UNITED STATES
NUCLEAR REGULATORY COMMISSION
WASHINGTON, D.C. 20555-0001

December 20, 2019

SUBJECT: TECHNICAL REVIEW OF TANK 12H WASTE RELEASE
REPORTS AND ASSOCIATED IMPACT ANALYSIS (DOCKET
NO. PROJ0734)

Technical Review of Tank 12H Waste Release Reports and Associated Impact Analysis

Figure 1. DOE Sensitivity Analysis on Pu Solubility (SRR-CWDA-2010-00124, Figure 6.3-23).

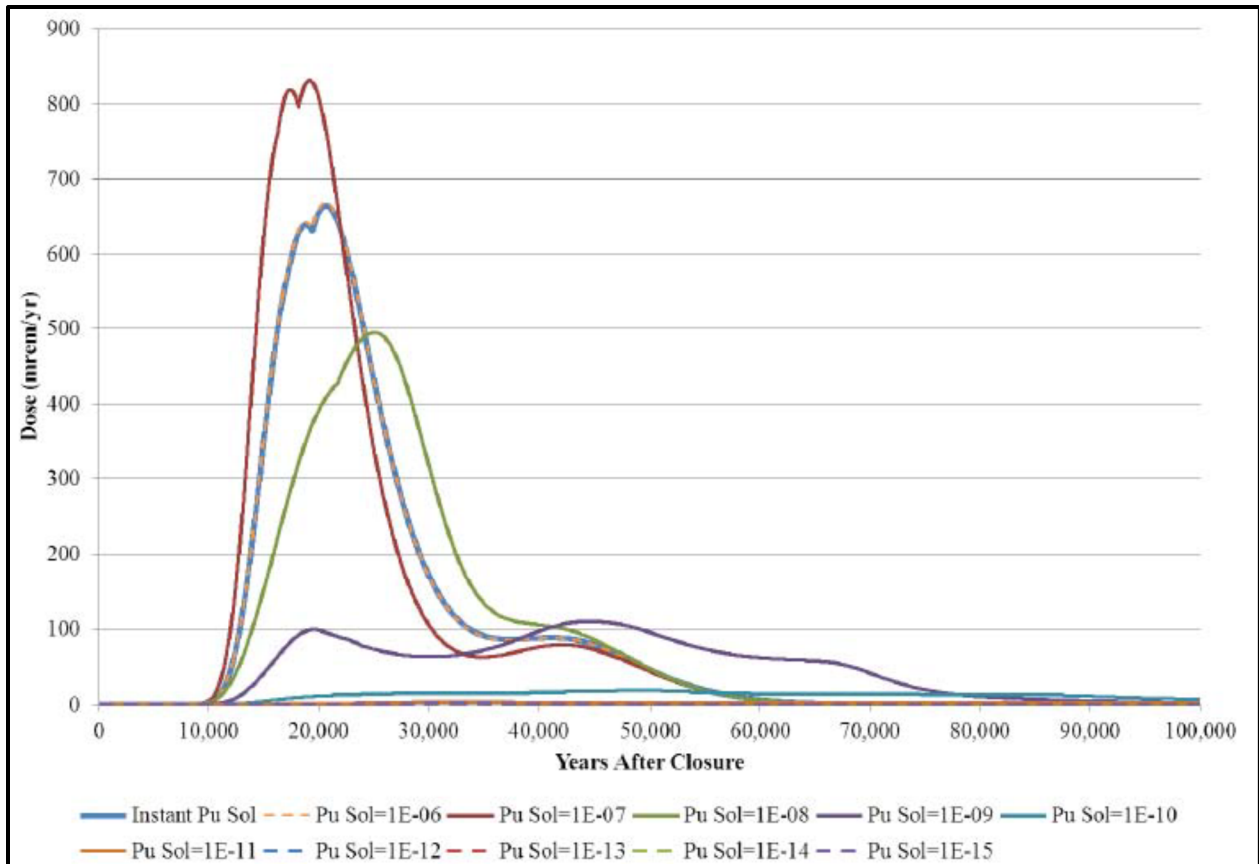
Finally, NRC would note that DOE sensitivity analyses conducted for Tank 18F show that Pu solubilities in the range of no solubility control to 1E-06 mol/L lead to lower doses compared to lower solubilities. This counter-intuitive result occurs due to upwards diffusion of relatively high solubility Pu into the tank grout in DOE's Type IV tank, near-field model prior to tank failure. In fact, the Pu concentration leading to the highest dose was found by DOE to be approximately 1E-07 mol/L (see Figure 1 below). Therefore, concentrations higher than 1E-07 mol/L would lead to lower doses using DOE's Type IV tank near-field model. Because Pu concentrations up to 3E-07 mol/L in wash solutions were observed during the Tank 18F waste release experiments (see discussion in ADAMS Accession No. ML18242A259), NRC staff is concerned that there is a potential for the most risk-significant release of Pu from Tank 18F based on DOE's PA modeling. NRC staff will continue to evaluate the reasonableness of DOE PA model assumptions which indicate that no solubility control could lead to lower doses for Pu in Type IV tanks such as Tank 18F.

DOE goes on to state that that while Pu might not be quite as insoluble as assumed in the tank farm PA, it is still relatively insoluble and would therefore not be expected to contribute to the peak doses within 10,000 years (SRR-CWDA-2016-00086). Because solubility primarily affects magnitude and not timing of peak dose, this statement is unclear. Additionally, the most risk-significant release concentration of $3E-07$ mol/L observed in the Tank 18F waste release testing was for a washed sample prior to leach testing which suggests the highest release concentration might be associated with an early release fraction of relatively oxidized groundwater in contact with the waste (an alternative conceptual model in DOE's PA).

Figure 2. FTF Peak MOP Doses for Various Pu Solubility Values. See Figure 4.3.2-8 in SRR-CWDA-2016-00086, Rev. 1.

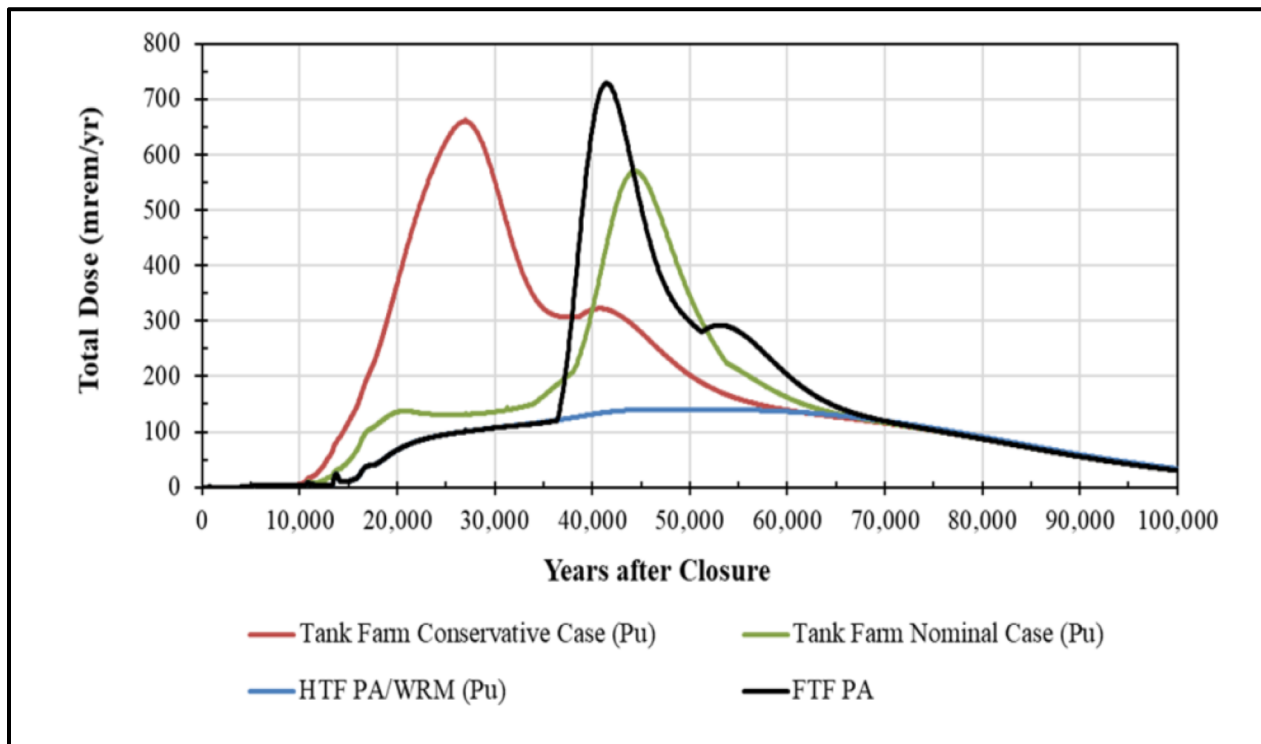
DOE evaluated the impact of potentially higher solubility values using the HTF and FTF GoldSim™ models in a deterministic mode (SRR-CWDA- 2018-00075). See Figure 2 below. The results for FTF are similar to results presented in the Tank 18F waste release PA impact report with doses over 0.25 mSv/yr just after 10,000 years and approaching 7 mSv/yr (700 mrem/yr) over longer time periods (20,000 to 30,000 yrs)⁷. The Tank Farm solubility values used in these new base case model runs are presented in SRR-CWDA-2016-00086, Rev. 1, Table 4.3.2-1, along with the solubility values used in HTF (SRR-CWDA-2010- 00128) and FTF (SRS-REG-2007-00002) PA modeling. See Table 7 below for ease of reference. The "Tank

⁷ Uncertainty in the timing of risk-significant concentrations and dose is also an NRC staff concern. For example, consideration of higher mobility forms of Pu could lead to doses above the 0.25 mSv/yr performance objective within 1000s of years. Additionally, the updated GSA PORFLOW (2018) model shows that peak concentrations and dose could be a factor of two higher than shown in Figure 2.

While DOE performed a sensitivity analysis to evaluate the impact of sandy soil K_d on the results, as stated previously, multiple fractions of varying mobility were not considered independently as discussed in NRC staff's FTF Technical Evaluation Report (TER) (ADAMS Accession No. ML112371715), Appendix E of FTF and HTF Monitoring Plan (ADAMS Accession No. ML15238B403), and the NRC's Tank 18 special analysis and waste release TRRs (ADAMS Accession Nos. ML13100A230 and ML18242A259). Additional model support is needed for DOE's selection of K_d values as well as their treatment of different oxidation states of Pu with significantly different mobility in the natural system. Based on NRC staff analysis, use of an average K_d is generally inappropriate when the magnitude of the K_d varies orders of magnitude.

Figure 3. FTF Peak Member of the Public Doses for Various Tc Solubility Values—20K Years. Image credit: Figure 4.3.3-8 of SRR-CWDA-2016-00086, Rev. 1.

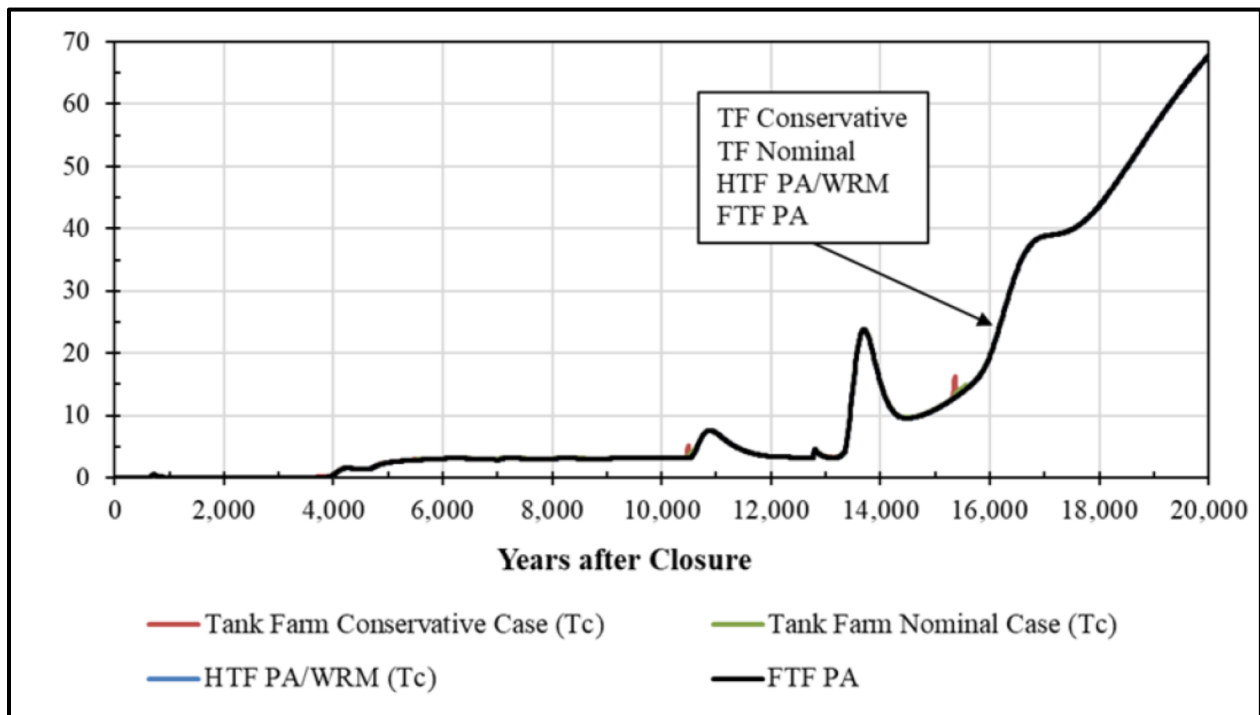
DOE also evaluated the impact of potentially higher Tc concentrations on the results. Table 8 below provides information on the assumed solubilities used in the GoldSim™ simulations. Given the limited inventory of Tc, the impact of higher assumed Tc solubilities had no significant impact on the FTF PA results (see Figure 3) and minimal impact on the HTF PA results (see Figure 4) within 20,000 years.

Figure 5. HTF Peak Member of the Public Doses for Various I Solubility Values—10K Years. Image credit: Figure 4.3.5-5 in SRR-CWDA-2016-00086.

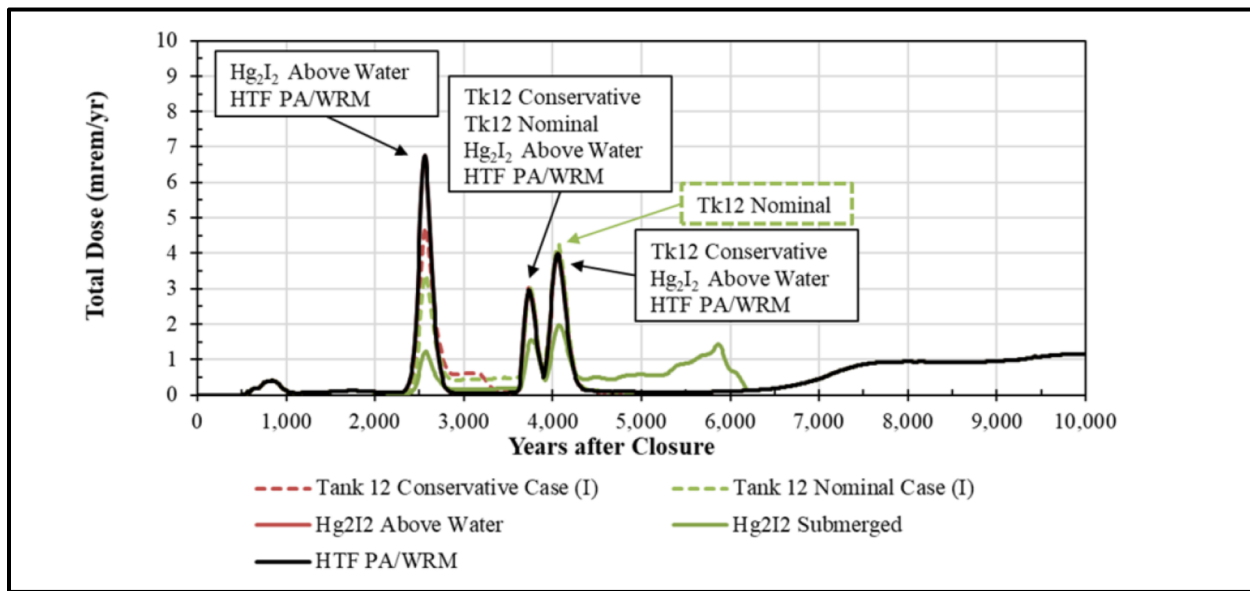
Overall, the solubility testing results for RRII, ORII, and ORIII indicate iodine is much less soluble than assumed in the TF PAs. A table of values simulated using GoldSim™ to assess the impact of various iodine solubilities on the PA results is provided in Table 9 below. The AgI and Hg_2I_2 iodine solubility cases were based on the findings of SRNL-STI-2015-00339 but did non-mechanistically assume that iodine solubility controls were present in RRII and/or submerged Region C (SRR-CWDA-2016-00078). As seen in Figure 5 below, assuming the Tank 12H derived I solubility values (i.e., using the I solubility values from Table 9) decreases the peak dose (accounting for all sources and all radionuclides) within 10,000 years for HTF.
